REMARKS

Applicant : Paul Mills
Serial No. : 10/828,409
Filed : April 20, 2004
Page : 13 of 13

Attorney's Docket No.: 11033-065001 / A10871US

FIG 1

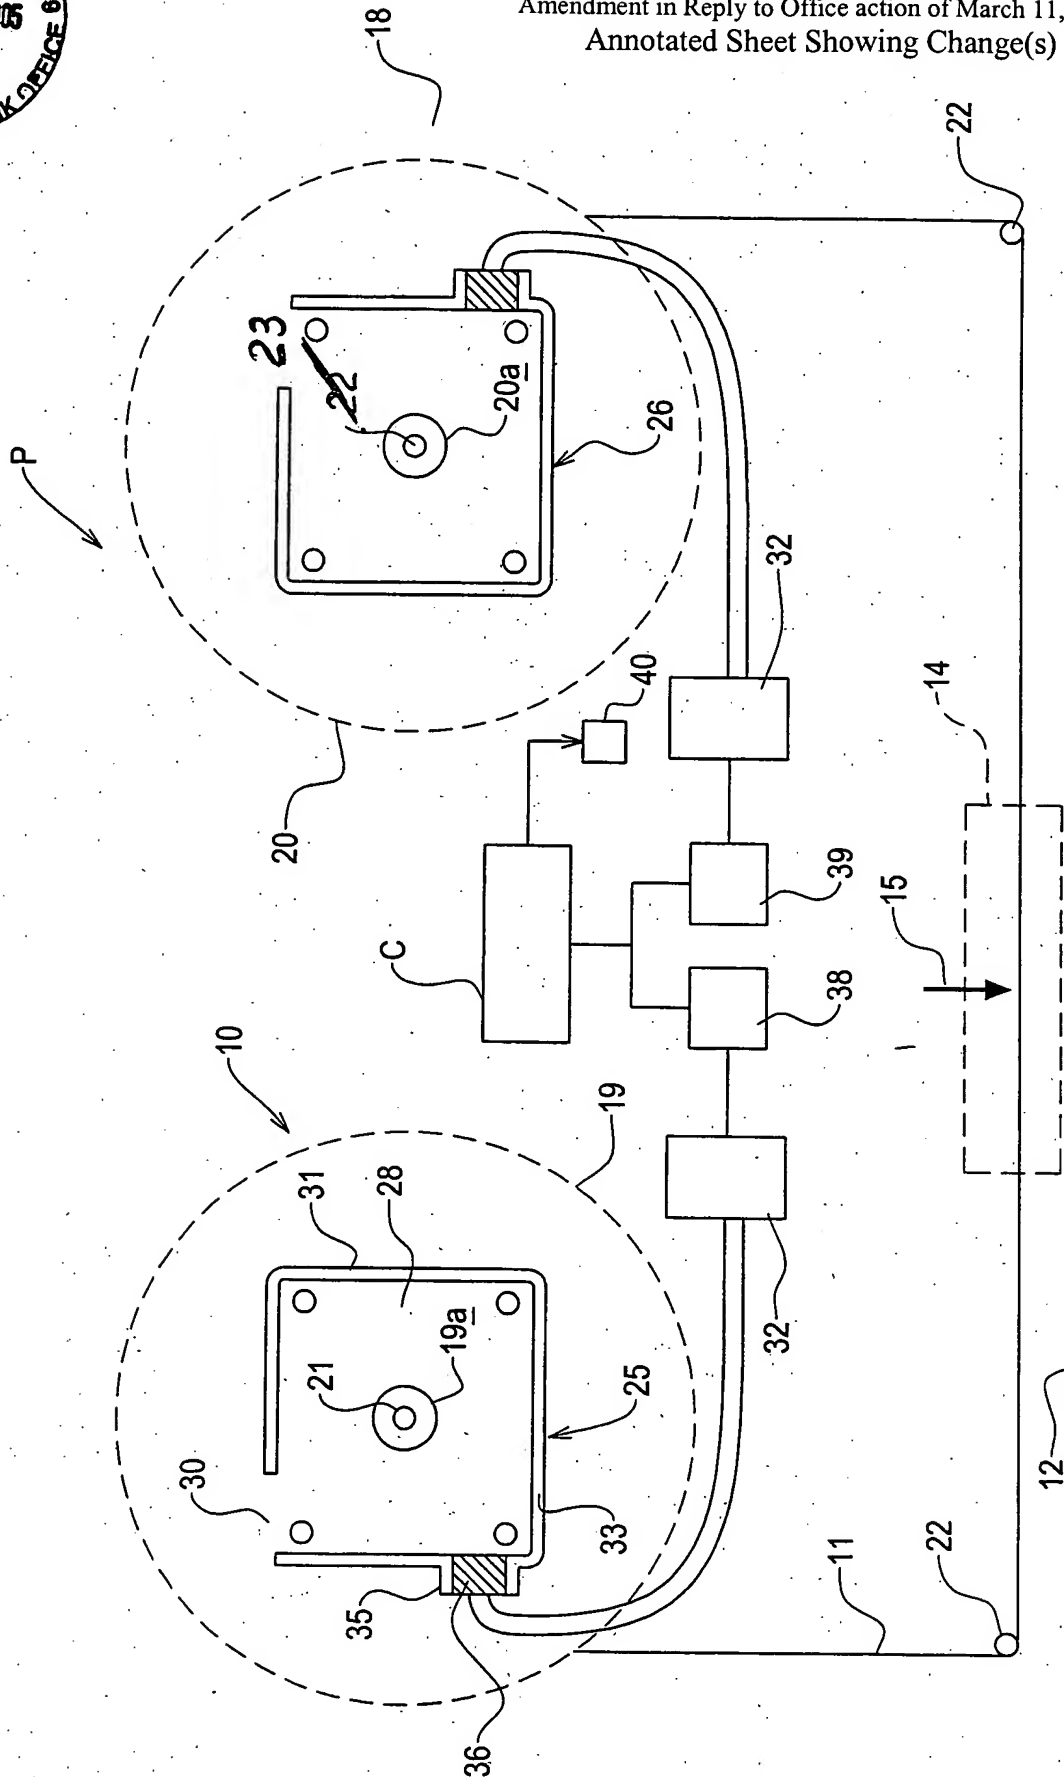
We acknowledge the Examiner's objections to the drawings and propose amending Fig. 1 to correct misidentified reference numerals and to add missing reference numerals (indicated in red on the attached sheet). These corrections conform the figures to the specification. We ask that the Examiner approve the drawing changes.

In Figure 1 the misidentified reference numeral "22" is replaced by the correct reference numeral "23."
